Whitebox Student Campus,
Groody Road, Newcastle,
Castletroy, Co. Limerick

Stage 1 Quality Audit

Stage 1 Road Safety Audit

Document Ref:	P24170-PMCE-XX-XX-RP-SA-3_0001
---------------	--------------------------------

2.1 Pedestrian Desire Lines within the Development

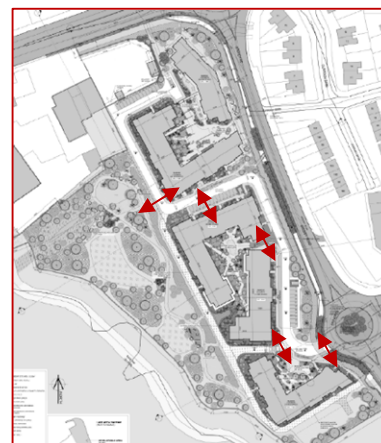
Pedestrian crossings have not been indicated at pedestrian desire lines within the development. No pedestrian crossings have been indicated at the following locations:

- Between the central public open spaces and the surrounding residential development/.
- Between parking spaces and the footpath on the opposite side of the road.
- At the development access and internal vehicular accesses.

A failure to provide an appropriate crossing for non-motorised road users at these expected desire lines could result in difficulties when crossing the carriageway, particularly for mobility and visually impaired pedestrians.

A thorough review of the likely pedestrian desire lines within the development should be undertaken, and suitable pedestrian crossings, including dropped kerbs and tactile paving, provided to facilitate safe VRU movement.

2.2 Pedestrian Desire Lines to/from the Footpath on Groody Road

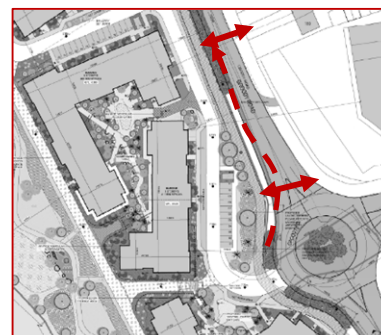
It is likely that pedestrian desire lines will exist between the proposed development and the neighbouring residential area to the east on the opposite side of Groody Road. Two pedestrian accesses to the proposed development have been indicated on Groody Road, however, no footpath is currently provided on the western side of Groody Road, nor are any pedestrian crossings provided, or proposed, connecting the development with Curragh Birin, including at the Groody Road/Curragh Birin roundabout.

If pedestrian facilities, including footpaths and formal pedestrian crossings, with dropped kerbs and tactile paving, are not provided on Groody Road, this may lead to difficulties for pedestrians, particularly the mobility and visually impaired, such as wheelchair users, in independently navigating the road layout.

Pedestrian facilities should be provided on Groody Road, including a footpath on the western side of the road and pedestrian crossings, with dropped kerb and associated tactile paving, to cater for pedestrian desire lines.

2.3 Steep Gradient

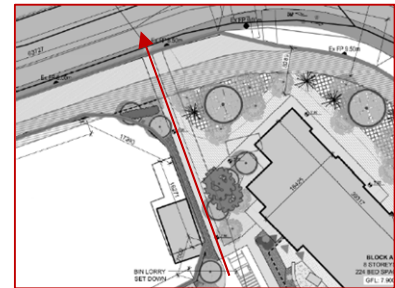
A pedestrian access onto the footpath on the southern side of Dublin Road has been indicated at the northern boundary of the proposed development. Due to the existing level difference between the land within the development site and this footpath it is unclear if the gradient of this path would be suitable for all pedestrians, particularly the mobility impaired. Should the path gradient exceed 1V:20H, it will create difficulties for mobility impaired pedestrians to traverse.

Ensure the proposed ramp gradients are suitable for all road users.

2.4 No Dropped Kerb/Tactile Paving at Accessible Parking Spaces

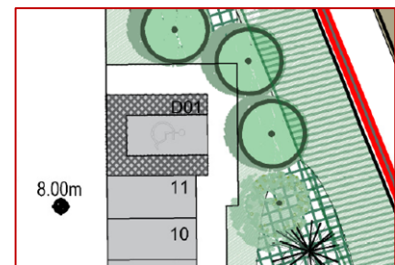
Two accessible parking spaces have been indicated within the proposed development. Dropped kerbs, and tactile paving, have not been indicated at these parking spaces. This may lead to mobility impaired vehicle occupants having to travel within the carriageway to a suitable location to access the footpath, which may be a lengthy journey, or have to mount/dismount full height kerbs to access a footpath.

Dropped kerbs, and tactile paving, should be provided adjacent to accessible parking spaces.

3.1 Pedestrian Desire Lines within the Development

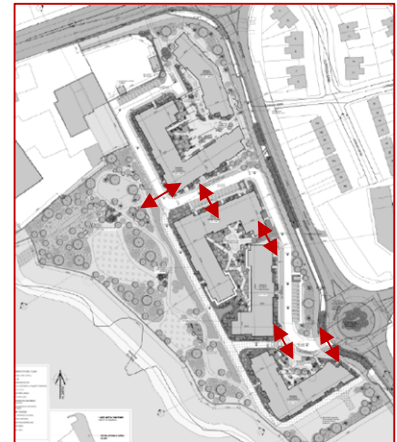
Pedestrian crossings have not been indicated at pedestrian desire lines within the development. No pedestrian crossings have been indicated at the following locations:

- Between the central public open spaces and the surrounding residential development.
- Between parking spaces and the footpath on the opposite side of the road.
- At the development access and internal vehicular accesses.

A failure to provide an appropriate crossing for non-motorised users at these expected desire lines could result in difficulties in crossing the carriageway, particularly for mobility and visually impaired pedestrians.

A thorough review of likely pedestrian desire lines within the development should be undertaken, and suitable pedestrian crossings, including dropped kerbs and tactile paving, provided to facilitate safe VRU movement.

3.2 Pedestrian Desire Lines to/from the Footpath on Groody Road

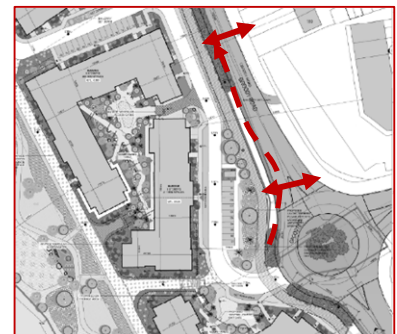
It is likely that pedestrian desire lines will exist between the proposed development and the neighbouring residential area to the east on the opposite side of Groody Road. Two pedestrian accesses to the proposed development have been indicated on Groody Road, however, no footpath is currently provided on the western side of Groody Road nor are any pedestrian crossings provided, or proposed, connecting the development with Curragh Birin, including at the Groody Road/Curragh Birin roundabout.

If pedestrian facilities, including footpaths and formal pedestrian crossings, with dropped kerbs and tactile paving, are not provided on Groody Road, this may lead to difficulties for pedestrians, particularly the mobility and visually impaired, such as wheelchair users, in independently navigating the road layout.

Pedestrian facilities should be provided on Groody Road, including a footpath on the western side of the road and pedestrian crossings, including dropped kerb and associated tactile paving, to cater for pedestrian desire lines.

3.3 Absence of Seating on Groody Valley

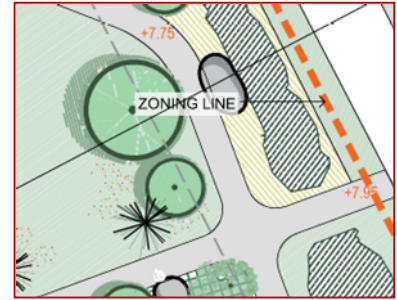
No seating or benches have been indicated within the public open spaces and paths on Groody Valley. Pedestrians, particularly the mobility impaired, may have difficulties walking, or standing, for long periods leading to fatigue.

Seating should be provided within public open spaces and courtyards.

4.3 Absence of Cycle Route between the Development and Dublin Road

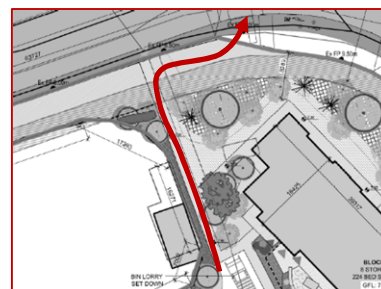
Existing cycle facilities and a Zebra crossing are provided on Dublin Road connecting the University of Limerick with Groody Roundabout. Whilst a pedestrian access onto the footpath on the southern side of Dublin Road has been indicated at the northern boundary of the proposed development, a route, and access, for cyclists has not been indicated at this location.

It is, therefore, likely to result in cyclists travelling within the footpath between Dublin Road and the development. The width of the proposed pedestrian route at this location would be insufficient for use by both pedestrians and cyclists resulting in conflicts between these road users.

The path connecting Dublin Road and the proposed development should be wide enough to cater for the expected types and volumes of non-motorised road users, including the provision of shared path sections on the route between Dublin Road and the proposed development.

'Ladder & Tramline' tactile paving should be provided where the shared paths would transition to pedestrian-only paths.

The ramp gradient at this location (see Issue 2.3) should also be suitable for cyclists.

3.1 Absence of Pedestrian Connectivity to Footpath on Groody Road

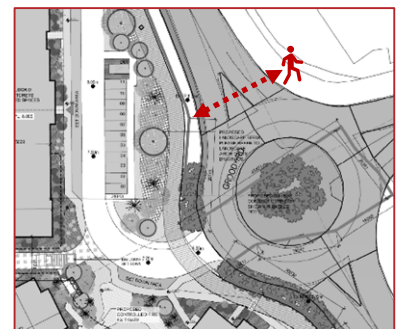
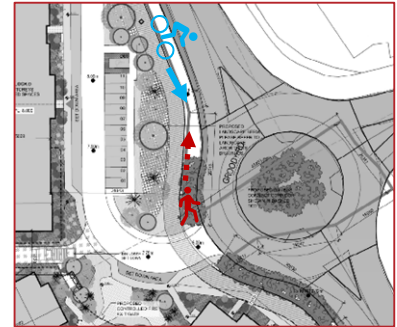
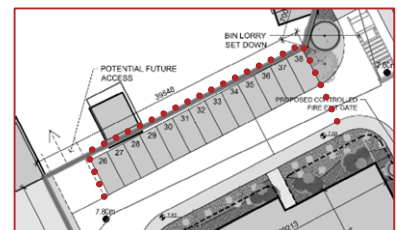
Summary: No pedestrian crossings have been indicated to/from the proposed development on Groody Road.

It is proposed to construct the student accommodation development on the western side of Groody Road with two pedestrian accesses indicated onto this side of the road, however, there is currently no footpath along the western side of Groody Road with an existing public footpath provided along the opposite side only. A pedestrian crossing has not been indicated on Groody Road with the nearest crossing being the Zebra crossing at the Groody Roundabout approximately 200m to the north.

There is likely to be a pedestrian desire line between the proposed development and the shops/residential developments on the eastern side of Groody Road, and it is unlikely that residents of the proposed development would travel north to this crossing. This may lead to pedestrians, who wish to travel between these developments, crossing Groody Road at locations where a driver may be less attentive to them, and insufficiently prepared to react, resulting in an increased risk of vehicle-pedestrian collisions.

There are also currently no pedestrian crossings at the roundabout at the proposed development access, which was noted as extremely busy at the time of the site visit, further exacerbating the problem.

In addition, the lack of a footpath on the western side of Groody Road will likely lead to pedestrians travelling in the verge or protected northbound cycle lane along the proposed development boundary, resulting in a risk of slips and falls, or pedestrian/cyclist collisions.

Measures should be provided to support the safe movement of pedestrians between the proposed development and developments on the eastern side of Groody Road.

3.3 Provision of Crossings

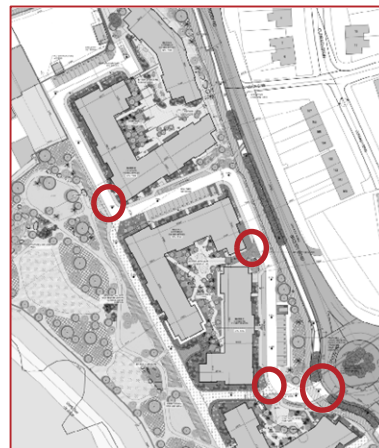
Summary: Details of pedestrian crossings within the development have not been indicated.

Pedestrian crossings have not been indicated within the development particularly at the development access and internal junctions where it is likely that these will be required to cater for pedestrians crossing the internal road network.

A failure to provide formal pedestrian crossings, with dropped kerbs and tactile paving, could lead to pedestrians crossing the carriageway at locations where drivers may be less attentive to them and insufficiently prepared to react safely resulting in an increased risk of vehicle-pedestrian collisions.

In addition, the lack of dropped kerbs and tactile paving at locations where pedestrians are likely to cross the carriageway would lead to pedestrians having to mount/dismount full height kerbs where there is a risk of trips and falls, and further accessibility issues for the visually and mobility impaired.

Pedestrian crossings, including dropped kerbs and tactile paving, should be provided at the development access and across side road junctions within the development.

3.4 Absence of Pedestrian Connectivity at Parking Spaces

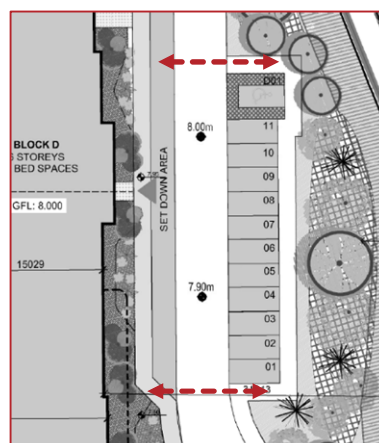
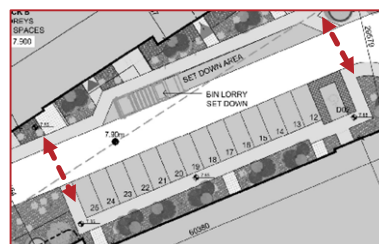
Summary: No pedestrian crossings have been indicated to cater for vehicle occupants travelling between their vehicle and the apartment blocks within the proposed development.

Parking spaces have been indicated within the proposed development on the opposite side of the development access road to the main entrance to Blocks B and D. Formal pedestrian crossings have not been indicated adjacent to these parking spaces to accommodate vehicle occupants crossing between their vehicle and the apartment blocks. A failure to provide a formal pedestrian crossing, with dropped kerbs and tactile paving, at these locations could lead to pedestrians, particularly mobility impaired pedestrians, being unable to safely and independently enter the carriageway to cross to the opposite footpath.

This could result in slips, trips and falls as these pedestrians attempt to descend the kerb, or an increased risk in visually impaired pedestrians unintentionally entering the carriageway where they could be struck by vehicles.

Formal pedestrian crossings, including dropped kerbs and tactile paving, should be provided at pedestrian desire lines between the proposed parking spaces and the opposite footpath adjacent the main apartment block entrances.

3.6 Restricted Forward Visibility at Bends

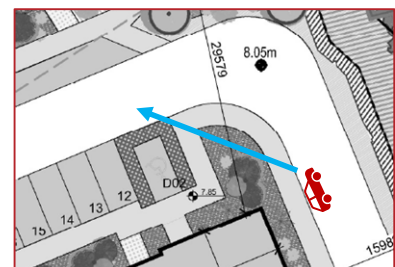
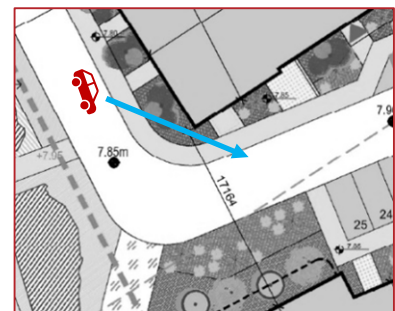
Summary: *Forward visibility of drivers within the proposed development may be restricted by proposed planting and building boundaries on the inside of horizontal curves.*

Horizontal curves have been indicated within the alignment of the development's internal access road between Blocks B and C. It is unclear if sufficient forward visibility will be available for drivers on the inside of these horizontal curves due to the trees and building boundaries located on the inside of the bend. This may lead to drivers being insufficiently aware of oncoming opposing traffic resulting in a risk of low-speed head on collisions.

Sufficient forward visibility should be provided for drivers on approach to, and throughout, the horizontal curves.

3.10 Level Difference

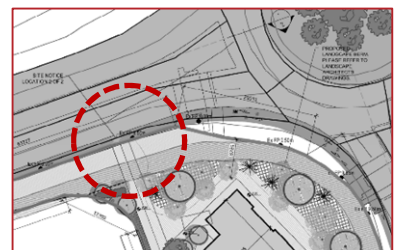
Summary: *The existing level difference between the site and the adjacent public footpath on the southern side of the R445 may result in a steep gradient on the proposed pedestrian path between the R445 and the development.*

A pedestrian route from the proposed development to the footpath on the southern side of the R445 has been indicated at the development's northern boundary. At the time of the site visit, the Audit Team noted a level difference between the development site and the footpath on the R445. It is, therefore, unclear if the gradient of this access path would be suitable for all pedestrians, particularly the mobility impaired. If not, this may increase the risk of slips, trips and falls and personal injuries.

The access path should have a smooth, non-slip surface and should provide a gentle gradient that can be safely traversed by all road users.

4 Observations

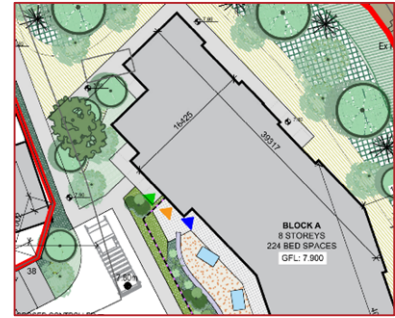
- 4.1 The Main Lobby Entrances have not been indicated at Blocks A and C. It is, therefore, unclear how pedestrians will access these blocks, i.e. from the development's internal footpath network or from routes between other apartment blocks. The Main Lobby Entrances should be clearly marked on the drawings and sufficient routes provided to these locations.
